T10/07-361r6

| To | From | Subject | Date |
|----------------------|---|---|--------------------------|
| INCITS T10 Committee | Curtis Ballard, HP Michael Banther, HP | SSC-3 Out of Band Encryption Key Management | <u>29</u> November, 2007 |

Figure 8 — UML example of SCSI target device and physical device

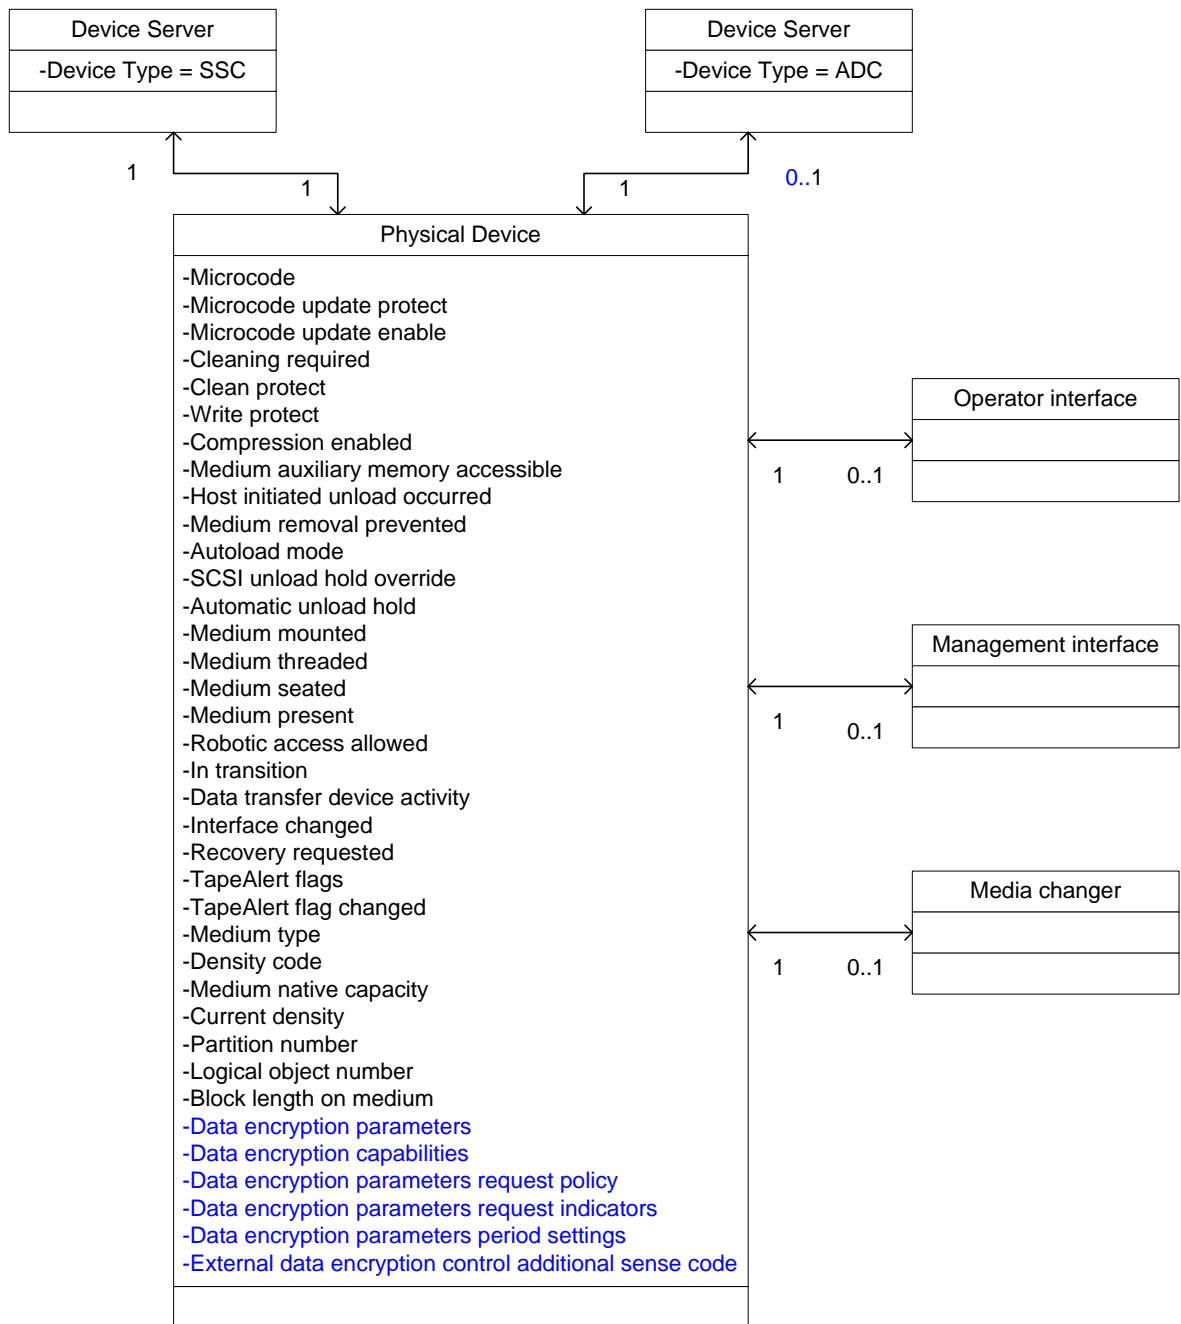
Add data encryption parameters, capabilities, request policy, request indicators, period settings, and ASC to figure 8.
